Packet Guide
City of Charlottesville
Board of Architectural Review
Regular Meeting
April 15, 2025 5:30 p.m.
Hybrid Meeting (In-person at Council Chamber and virtual via Zoom)

Recommendation for Special Exception Permits

Permit # PL-26-0126

Certificate of Appropriateness Application

All grades, counts and quantities are approximate and will change as design proceeds.

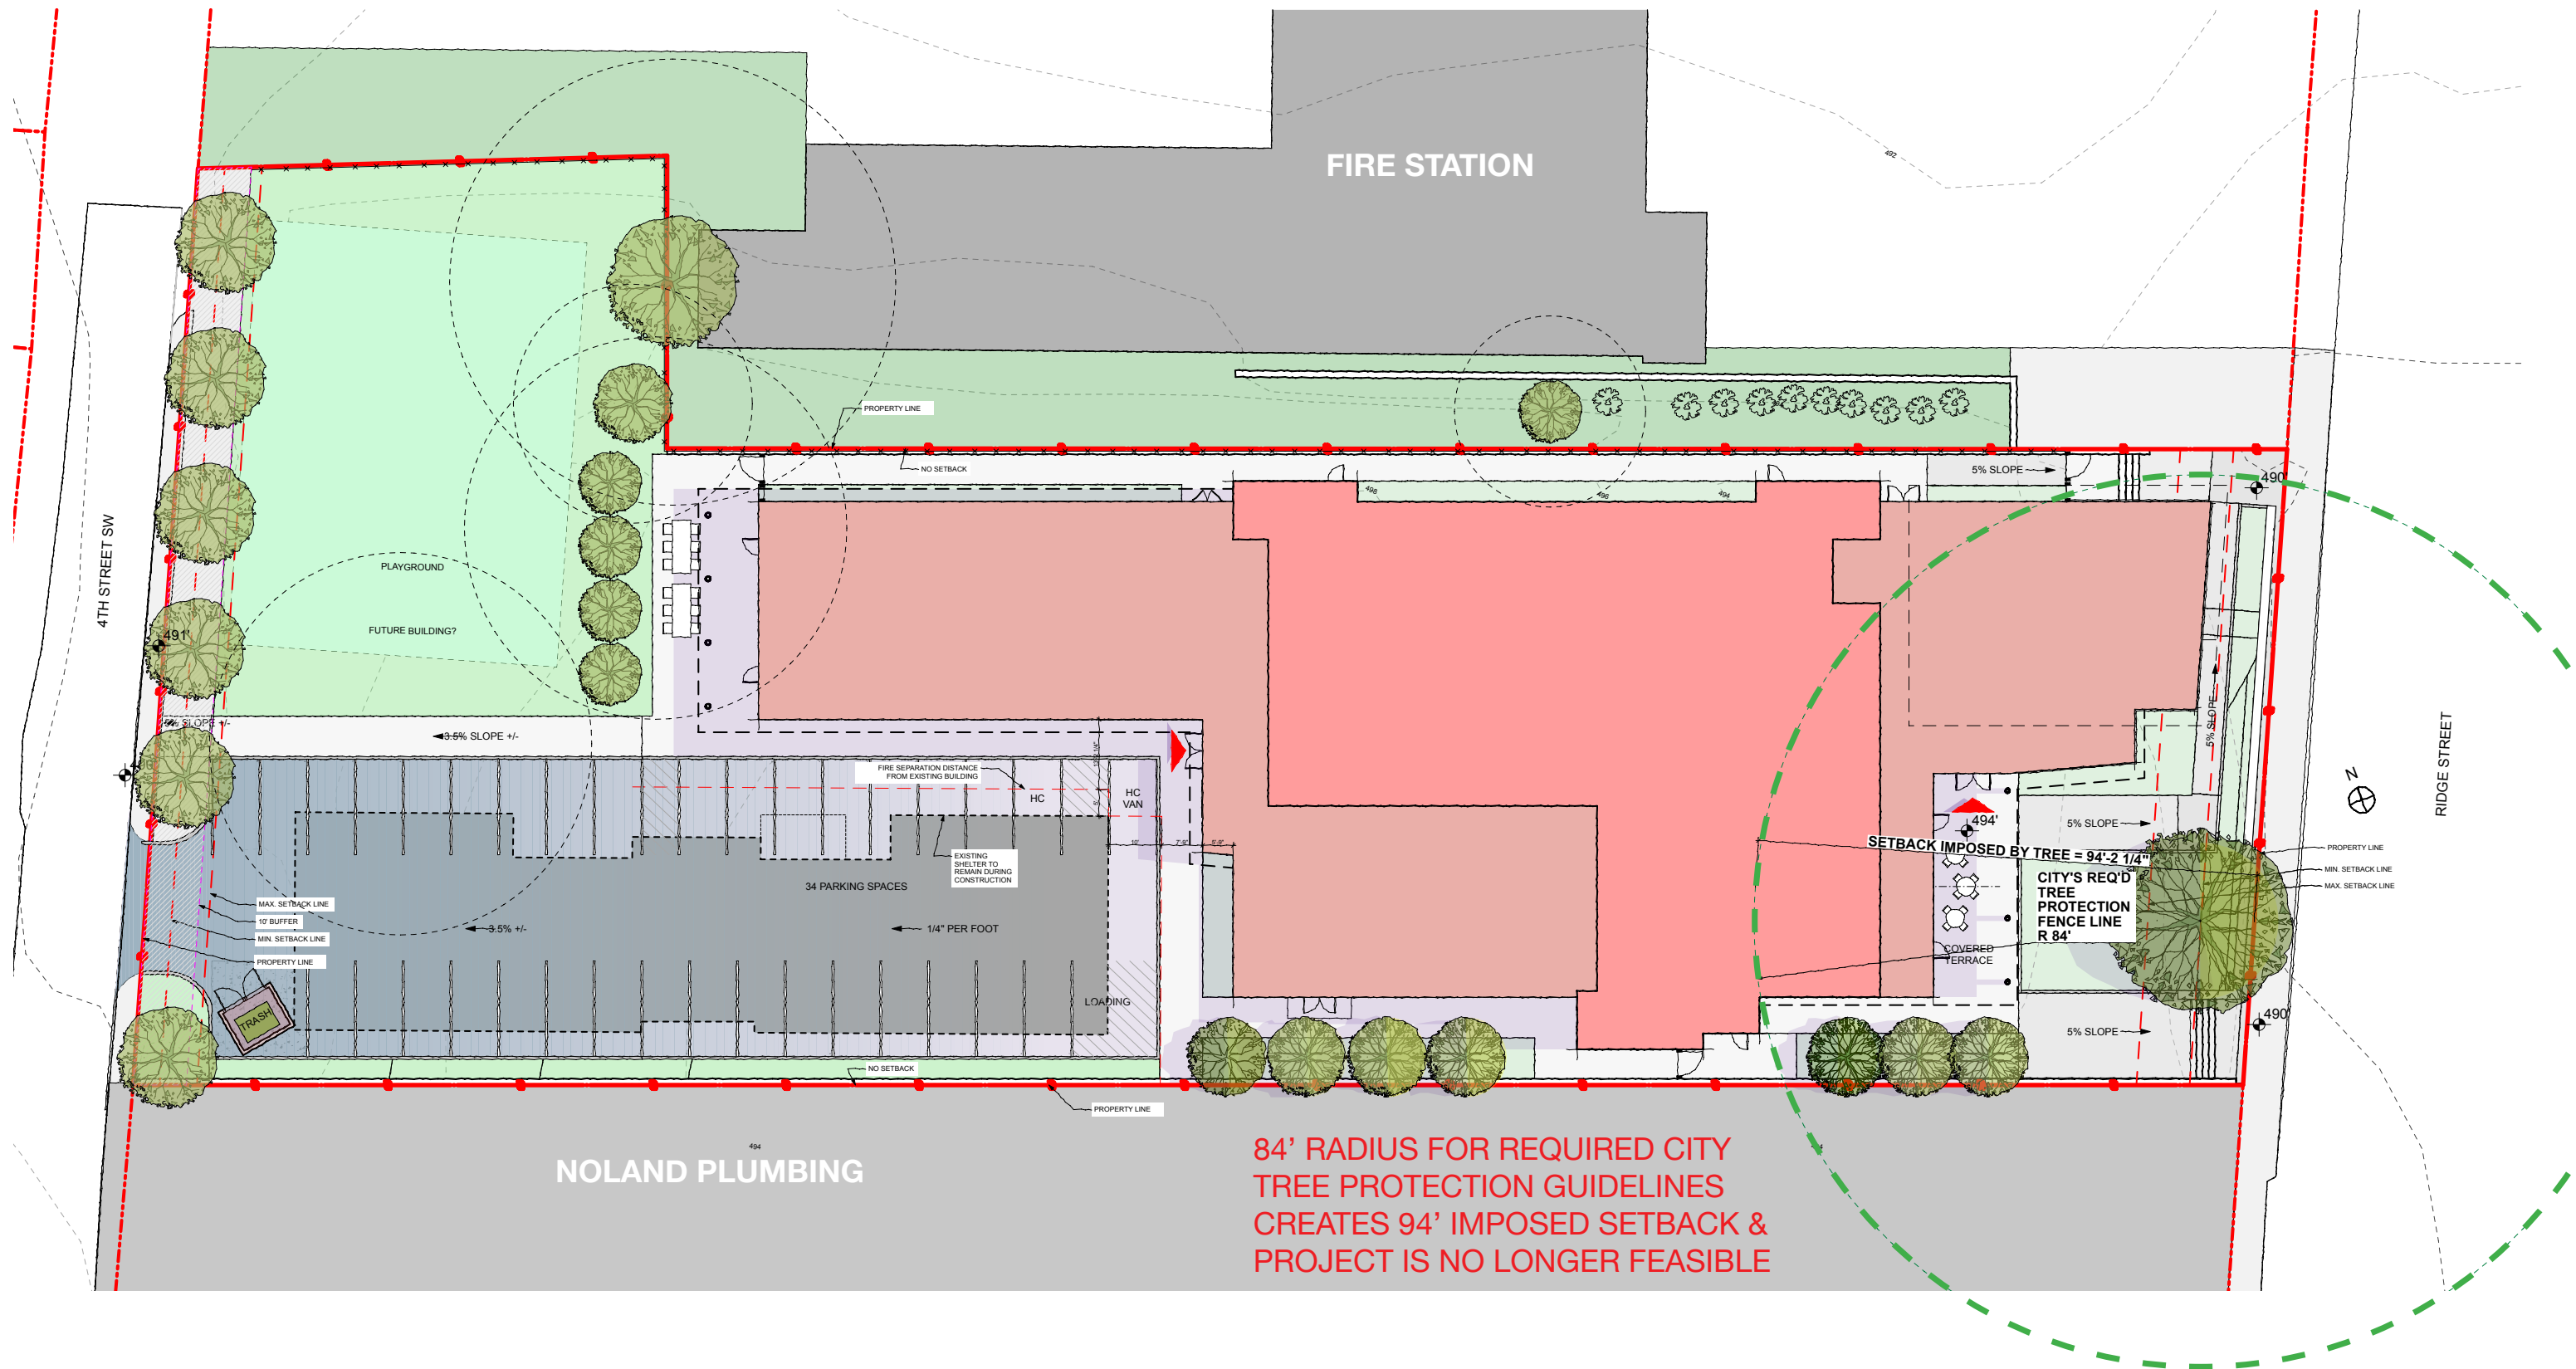
- The BAR does not find that the removal of the black oak at the front of the property is compatible with the guidelines and asks that the applicant develop a tree protection strategy based on the arborist recommendations submitted January 16, 2023. The applicant should apply all reasonable approaches to protect the tree during demolition and subsequent construction.
- The BAR recommends that the city engineer work with the applicant to review the tree protection plan that they have developed and adapt the city requirements to the particular context of this situation.

Provide sketch or images of proposed serving counter. Indicate materials and dimensions (height, width, and length).

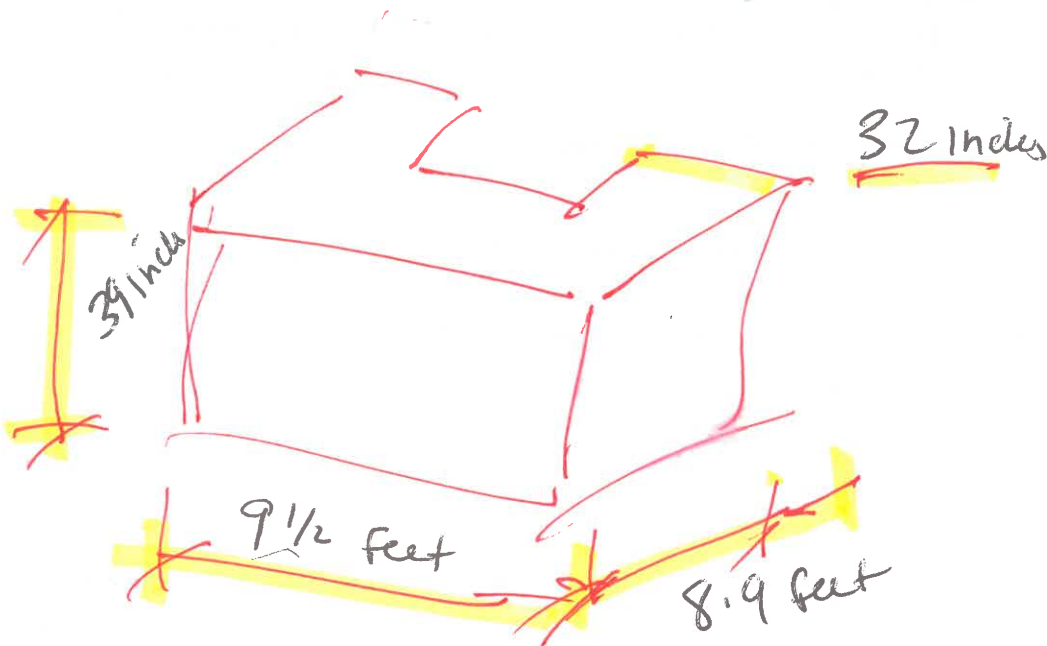
Staff comment: The serving counter is constructed as a single element and does not appear to be *portable and easily moved manually*.

Staff comment: Particle board is not a durable or high-quality material.

Staff comment: With the particleboard front and side panels, the serving counter reads as a solid element.

Staff comment: The serving counter is built directly on the tree grate, less than one foot from the tree trunk on all sides. To stabilize the cabinet, wooden braces span the gap and abut the tree trunk on two sides.
